Response to Reviewer #2

We appreciate your very meaningful comments.

Fig. The variability of LPS(=PF) ratio with regards to E/W and N/S direction. The results are from BATC model. It didn't include in manuscript, but you can check it out for reference.

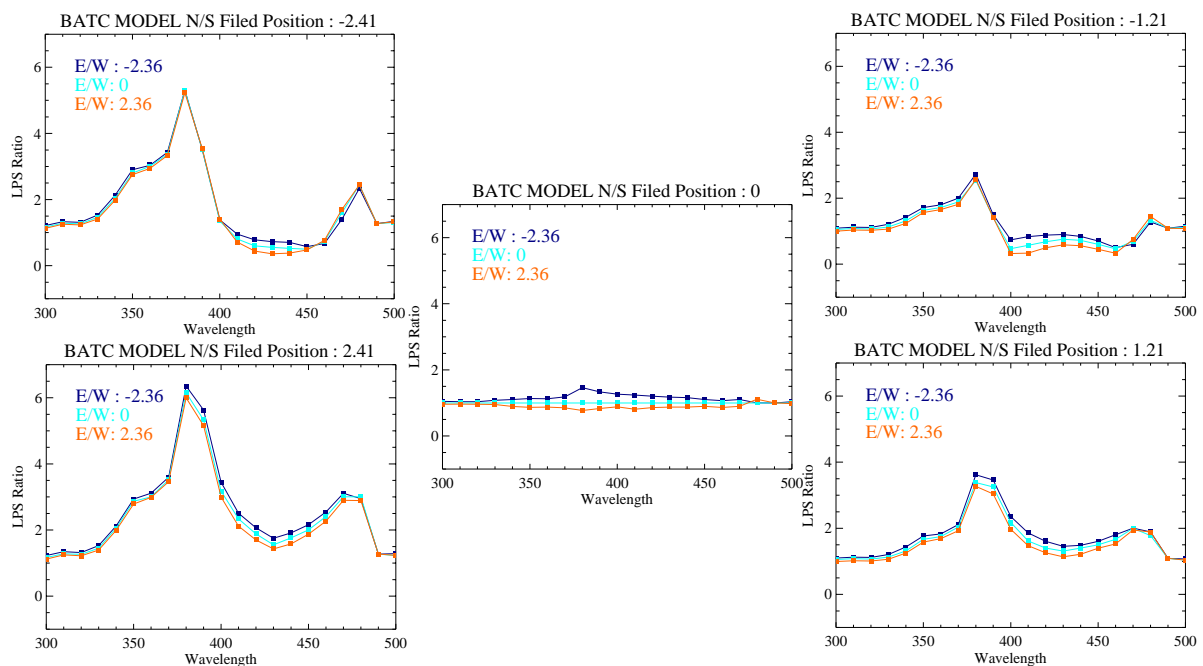
The discussion here of areas of uncertainty in the polarization correction is very important. These uncertainties deserve to be quantified rather than simply listed. The reader cannot assess the validity of the polarization correction without some estimation of these uncertainties. I understand it is a lot of work to come up with reasonable uncertainties, but that does not mean the authors can ignore the issue. The lack of PF information as a function of SMA angle is a good example. The authors offer a plausible approach to improving the characterization, and it is understandable they do not include such improvements in this paper. But they should include estimates of the uncertainties as a result of the SMA spatial dependence. Even though the authors do not have access to the original test data, there are ways of estimating the degree of S and P polarization from a reflecting aluminum surface given the incidence and view angles. It's true that we do not know exactly how the scan mirror is coated, but the goal here is to bound the error rather than to improve the characterization.

→ Revised, As answered for Section 4.1 above, we discussed uncertainty a bit more in the Discussion section. If aerosol is not taken into account and clear skies are assumed, the actual atmospheric polarization state can be misunderstood as large, and then overcorrection. Along the same line, If the cloud surface pressure is estimated lower/higher than the actual value, the polarization effect can be over/under corrected. In addition, the factor of shift/squeeze of the GEMS wavelength is also mentioned here (since the polarization error of GEMS is a function of wavelength, it is important to apply the correction at the correct wavelength position). Based on the results of the BATC model (as below figure), the change in the polarization spectrum of 350 to 400 nm can increase up to 6 times (in the N/S direction). Assuming the model results, a maximum polarization error can be 0.4% (worst case). Then, the polarization error of ~0.3% can be remained even after correction with the polarization correction algorithm proposed in this study.
